HISTORIC DISTRICT COMMISSION

6:30 p.m. June 4, 2025

Minutes

6:30 p.m. May 7, 2025

Elevations

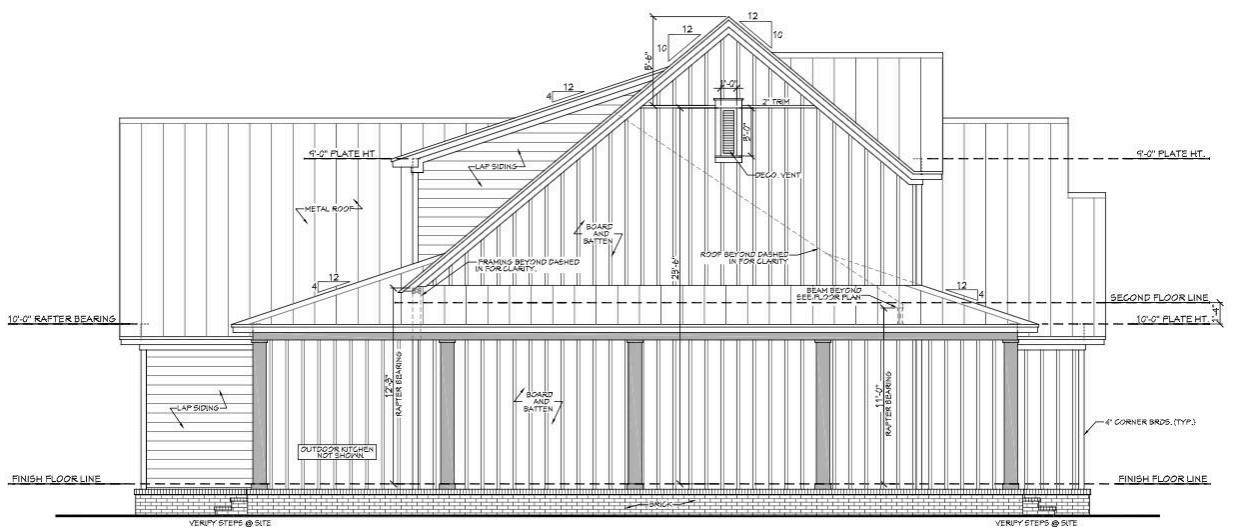
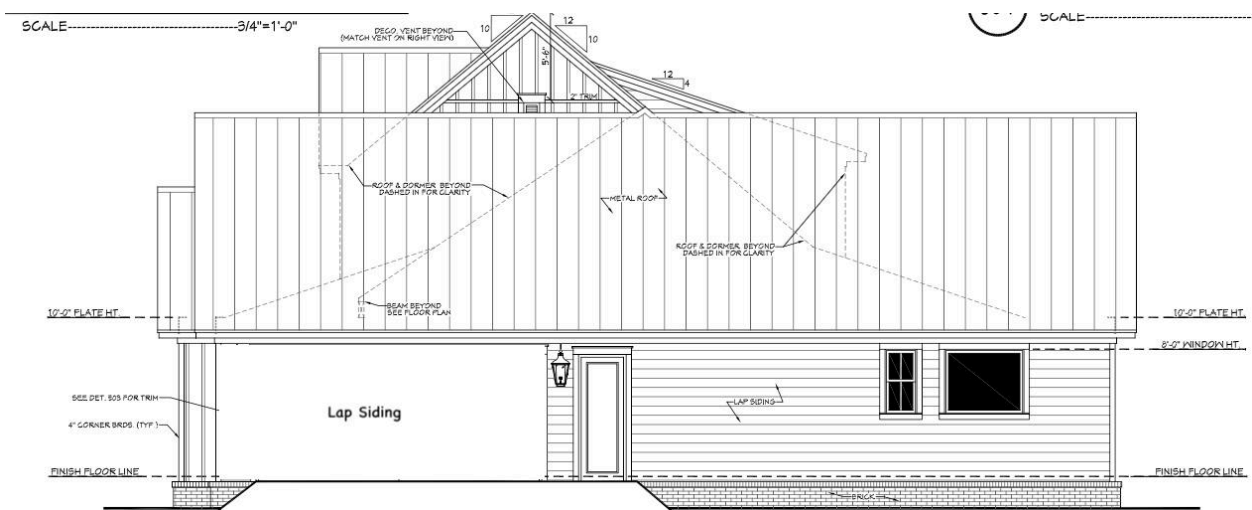
- The side elevations were split from a combined elevation into two separate elevations, but the fenestration plans for the west elevation and open area on the east elevation will need to be clarified.
